**BUILDINGS 5 & 6
RENOVATIONS**

BID ADDENDA

**SECOND FLOOR PLAN
- LIGHTING**

Date	08/29/08	Drawing Number	E2.2
Scale	AS NOTED	Project Number	07013

1 SECOND FLOOR PLAN - LIGHTING
0 4' 8' 16'
SCALE: 1/8"=1'-0"

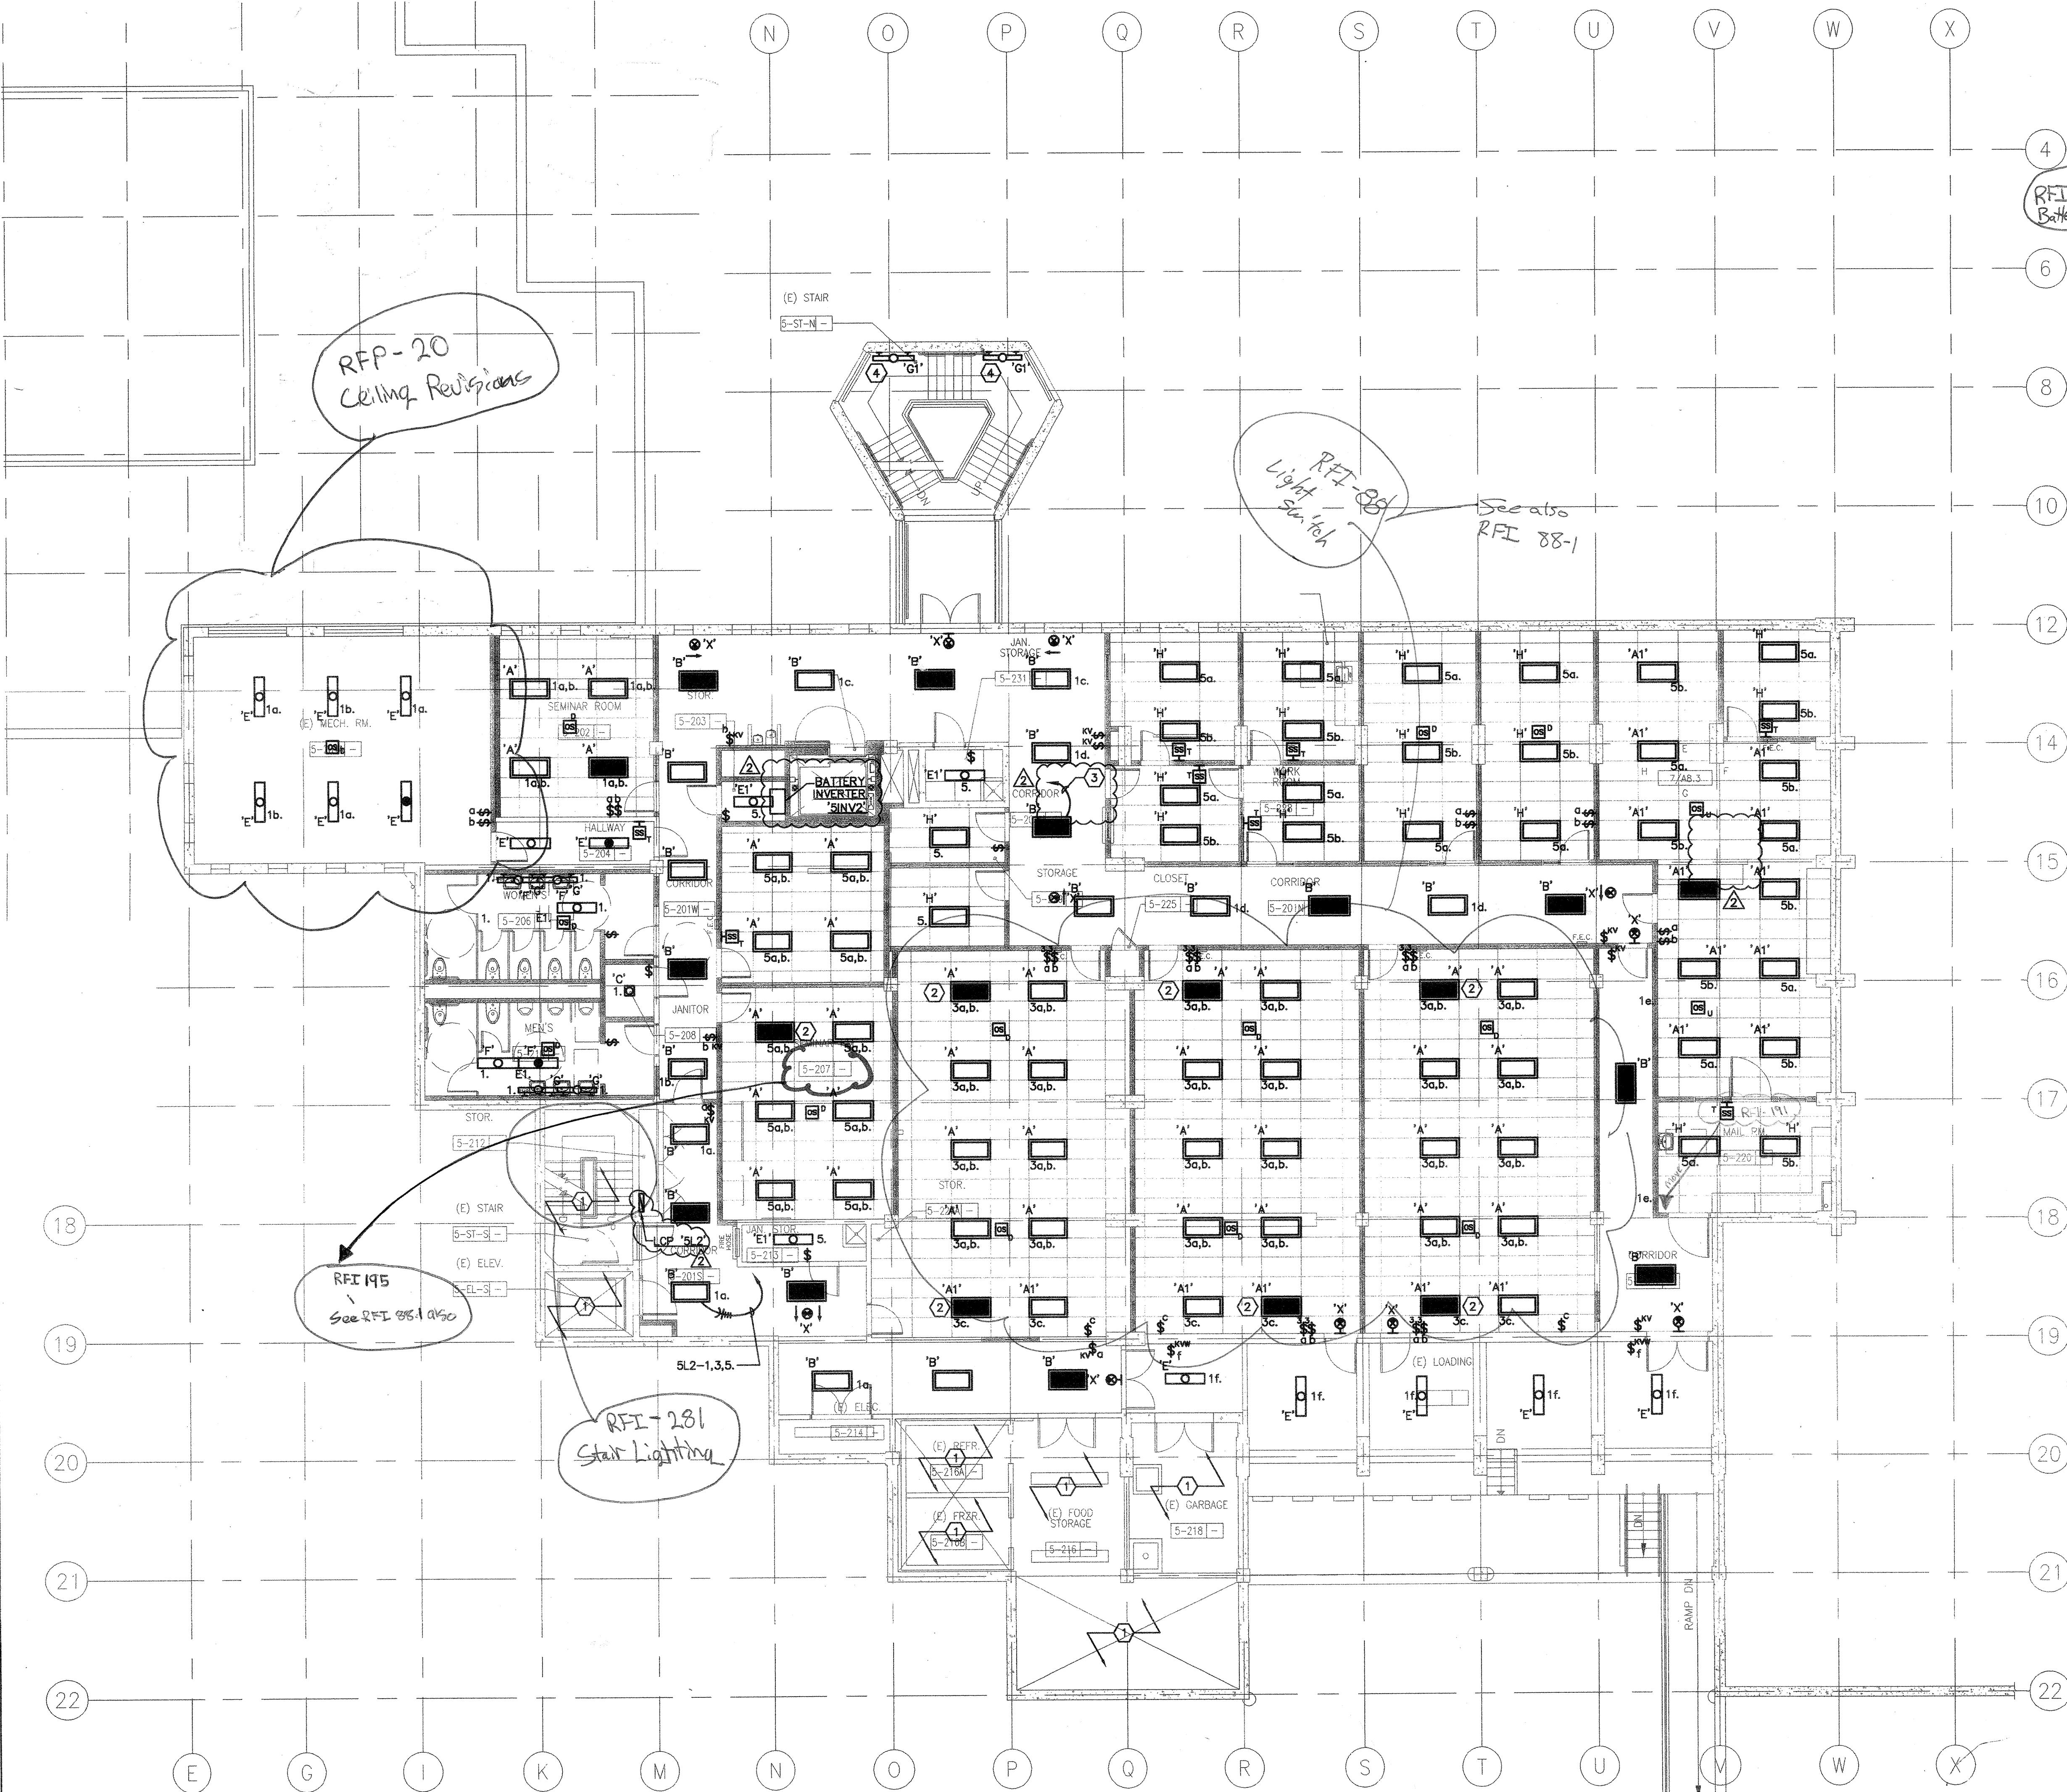
RFI-223
Battery Inverter

RFI-88
Light Switch
See also RFI 88-1

RFP-20
Ceiling Revisions

RFI 195
See RFI 88-1 also

RFI-281
Stair Lighting
